HARTZELL PROPELLER INC.  
**ALERT SERVICE BULLETIN**

**HC-ASB-61-279**

**Propeller - Propeller Mounting Bolt Inspection**

This page transmits Revision 4 to Alert Service Bulletin HC-ASB-61-279.

Bolt Head Identification  
Figure 1

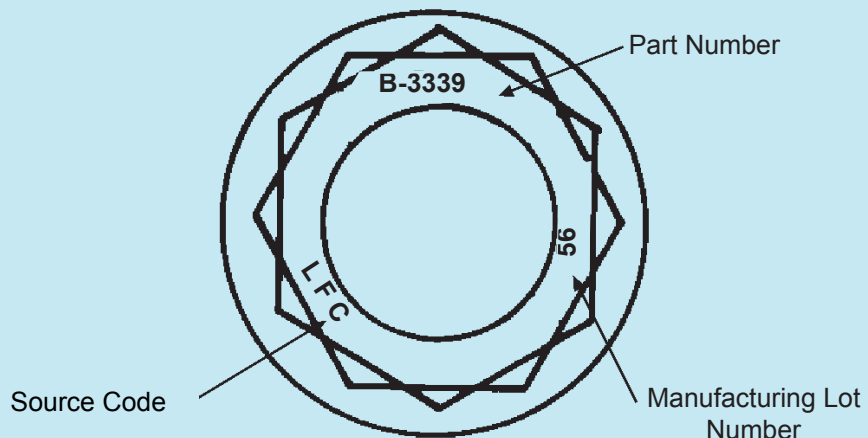
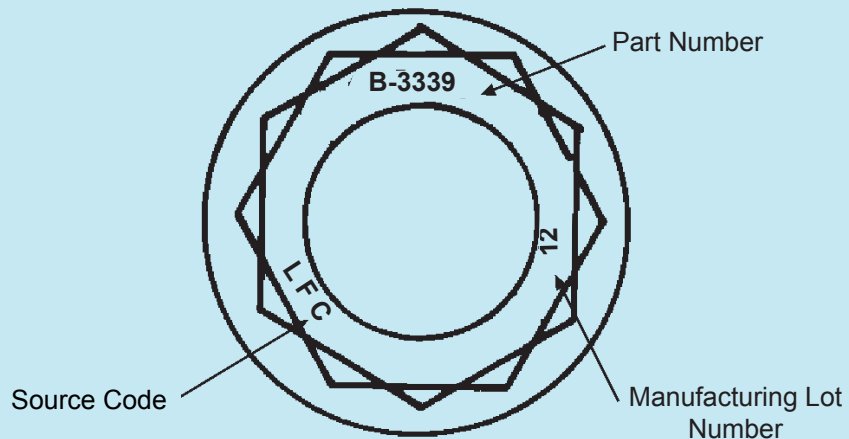
- (1) Hartzell propeller models HC-B(3,4,5)( ) (P,N)-( ) ( ) that were installed on an aircraft with B-3339 mounting bolts from LFC manufacturing lot number 12 or lot 56 are affected by this Alert Service Bulletin. B-3339 mounting bolts from LFC manufacturing lot 12 and lot 56 may be found in inventory between February 13, 2004 and July 5, 2006. Refer to Figure 1.

NOTE 1: Only bolts identified as the LFC manufacturing lot number 12 or lot number 56 are required to be replaced. Refer to Figure 1.

NOTE 3: This Alert Service Bulletin does not apply to mounting bolts with marking other than the marking shown in Figure 1.

- (1) Gain access to the B-3339 propeller mounting bolts.
- (2) Visually inspect the head of each B-3339 propeller mounting bolt for identification marks. Refer to Figure 1 for the location of the identification mark.

CAUTION 1: REMOVE ONE MOUNTING BOLT AT A TIME. ALL PROPELLER MOUNTING BOLTS THAT HAVE IDENTIFICATION MARKS "LFC" AND "12" OR "56" ON THE HEAD OF THE BOLT MUST BE REPLACED.

- (c) Remove one mounting bolt at a time and closely inspect each bolt identification.
- 1 Replace all propeller mounting bolts that have identification marks "LFC" and manufacturing lot number "12" or "56" on the head of the bolt in accordance with the Compliance section of this Alert Service Bulletin. Refer to Figure 1.
    - a Propellers with three or more LFC manufacturing lot number 56 bolts must replace all eight mounting bolts.
    - b Propellers with LFC manufacturing lot number 12 bolts must replace the lot 12 bolts only.
- (d) Re-torque all of the propeller mounting bolts in proper sequence, in accordance with the Installation and Removal chapter of the applicable Hartzell Propeller Owner's Manual.
- (e) Safety the mounting bolts with 0.032 inch (0.81 mm) minimum diameter stainless steel wire (two bolts per safety).
